Swan and Canning Rivers Management Act 2006

DETERMINATION OF DEVELOPMENT APPLICATION

FILE NUMBER	:	2023/4596
APPLICANT	:	East Fremantle Lawn Tennis Club
LANDOWNER	:	Town of East Fremantle
LAND DESCRIPTION	:	Lot 15722 (Reserve 7800) 1 Jerrat Drive, East Fremantle
DEVELOPMENT	:	Material change of use to allow night time tennis – installation of electric cabling and six (6) LED floodlights
VALID FORM 1 RECEIVED	:	14 August 2023
DETERMINATION	:	APPROVAL WITH CONDITIONS

DEPARTMENT OF BIODIVERSITY, CONSERVATION AND ATTRACTIONS REPORT

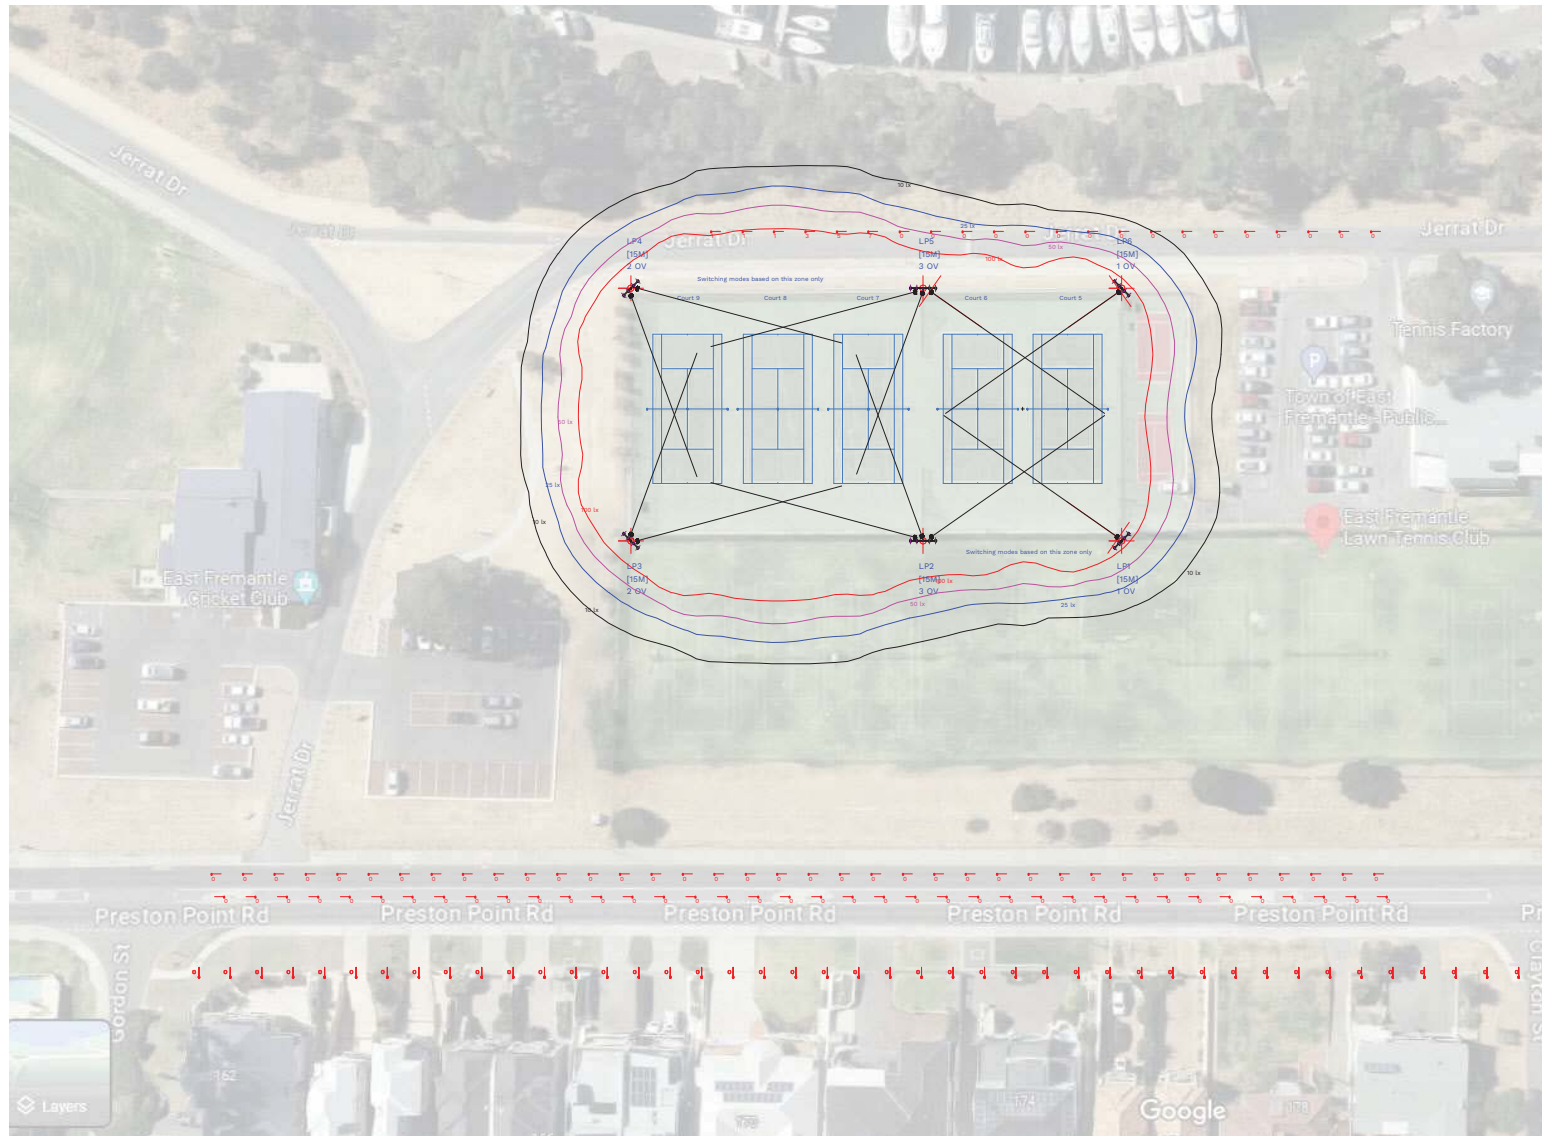
- 7.14 In addition, the applicant has provided an Obtrusive Light Assessment, which is based on the light limiting parameters and guidelines from Australian Standard AS/NZS4282:2019 *Control of the obtrusive effects of outdoor lighting*. The objective of AS/NZS4282 is to provide a common basis for assessment of the likely effects of developments that involve the provision of outdoor lighting. The Obtrusive Light Assessment demonstrates that the lighting proposed for the Club is fully compliant with parameters for spill light, luminous intensity at vertical planes, threshold increment and upward light ratio for both non-curfew (6am to 11pm) and the more stringent curfew requirements (applicable between 11pm to 6am). The Obtrusive Light Assessment is included in the Lighting Plan which can be found at **Attachment 1H**.

- 7.16 The Town recommended that light spill investigations be undertaken before and after installation of the light towers to ensure that surrounding residents are not adversely impacted. The lighting plan provided is considered sufficient to meet this requirement pre-installation. A condition of approval can require the Club undertake a lighting audit post-installation to demonstrate compliance with the plans provided.

Issue	DBC response
OBJECTION	
Lighting	
<p>Drawings have been provided but no written report for the Obtrusive Light Assessment. The assessment claims that the design of the lighting is compliant with all the various factors associated with Australian Standard AS/NZ4282.2019, however no actual survey data has been obtained.</p>	<p>The drawings provided include text confirming that the proposed lighting plan is compliant with AS/NZ4282.2019. Condition 3 will require survey data be obtained to demonstrate the lights have been installed in accordance with the plans.</p>
<p>The assessment has been based on a scaled aerial image to “estimate” property boundaries and roadways. As such the assessment can only be considered as an estimate and as such this does not fully demonstrate potential compliance with AS/NZ4282.2019.</p>	<p>The lighting plan demonstrates compliance with AS/NZ4282.2019 as far as reasonably possible prior to installation of the lights. A scaled aerial image would not change the assessment of the compliance with AS/NZ4282.2019. Condition 5 will ensure the lights have been installed in accordance with the plans.</p>

3. Regarding **Condition 3** all lighting is to be installed in accordance with the lighting plan prepared by Sylvania Schreder dated 13 November 2023. In particular, it should be noted that:
